Subject: **Geotechnical Response to City of Agoura Hills Review Sheet Dated September 91 2014, Senior Housing Community, Vesting Tentative Tract Number 71742 (APN# 2061-001-025), 30800 Agoura Road, Agoura Hills, California.**

2. RESPONSES TO GEODYNAMICS REVIEW LETTER DATED SEPTEMBER 91 2014

CITY OF AGOURA HILLS - GEOTECHNICAL REVIEW SHEET

WO 2272-1-0-101 with nails Section A-A' pseudo-static

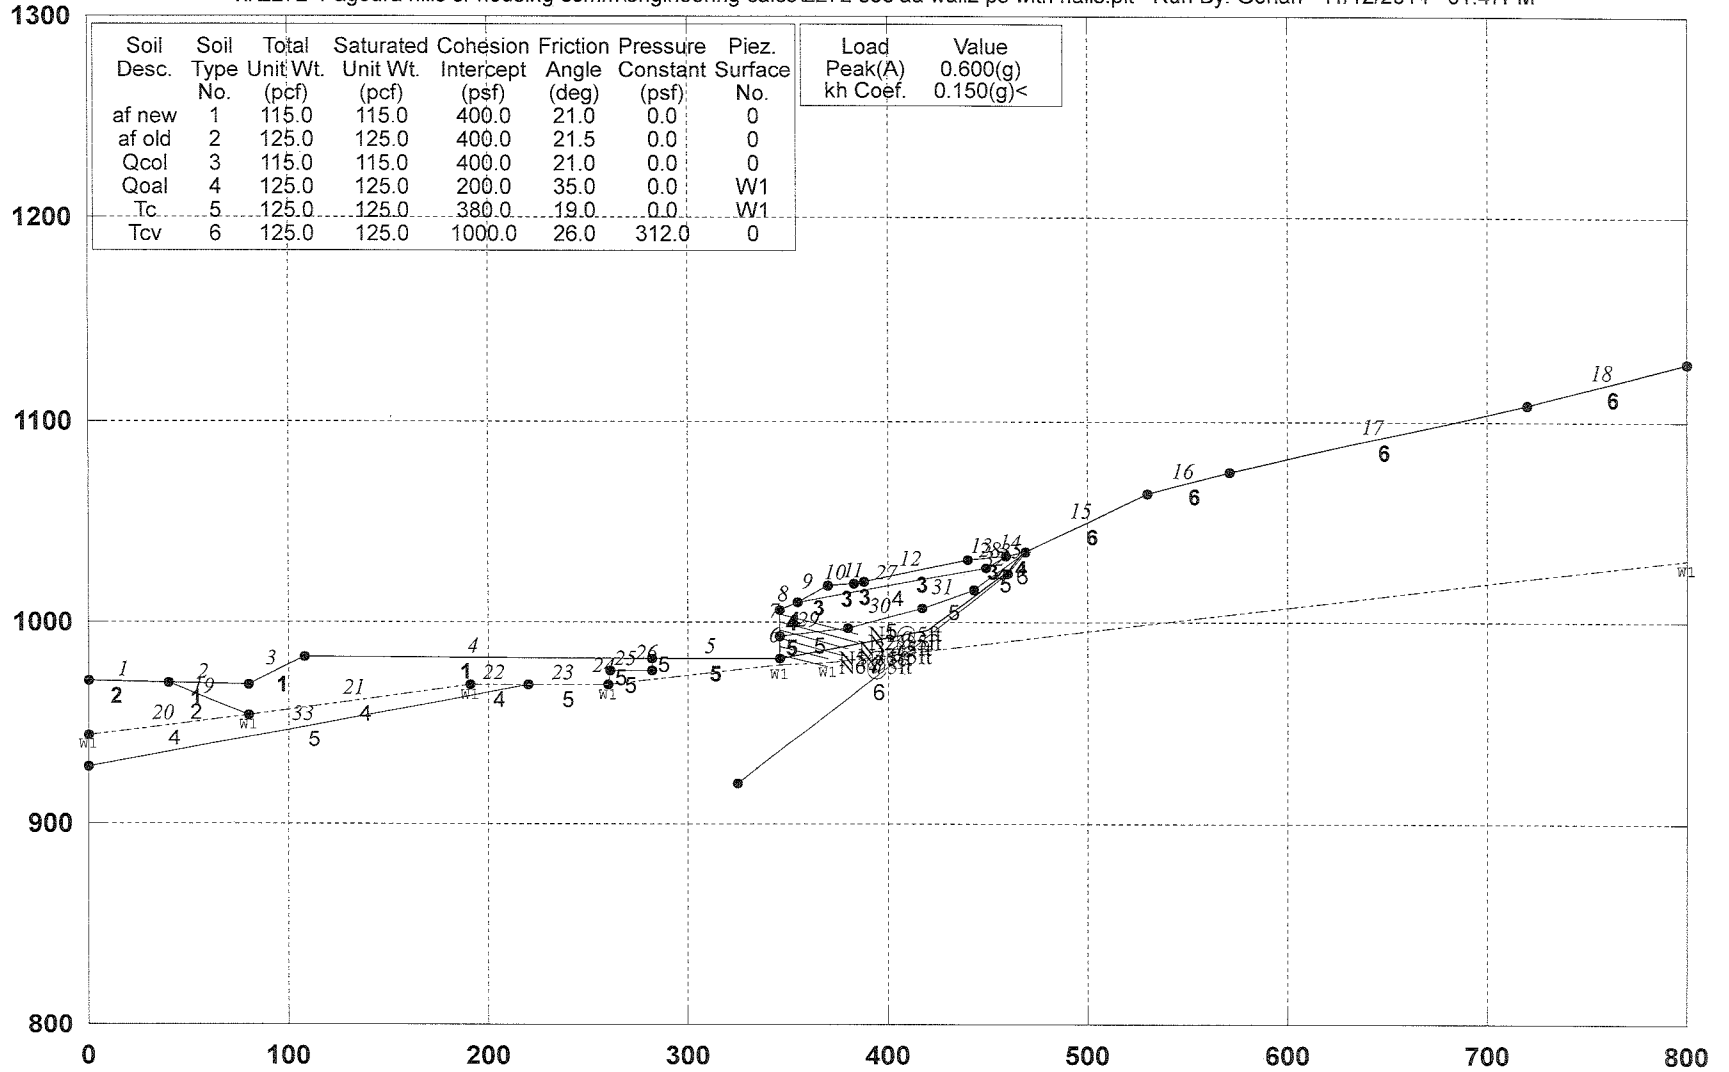
The consultant provided static translational analyses for potential unfavorably oriented surfaces in the Calabasas Formation at the base of the proposed soil nail wall. Seismic analyses should be provided as per the County of Los Angeles Guidelines.

The Los Angeles County Department of Public Works, Geotechnical and Materials Engineering Division (GMED) *Manual for Preparation of Geotechnical Reports* provides requirements for slope stability analyses and can be viewed at <http://dpw.lacounty.gov/gmed/permits/docs/manual.pdf>. Based the seismic analysis procedure outlined in the County guidelines, the requested analysis is presented in Appendix A, which resulted in a factor of safety above 1.1.
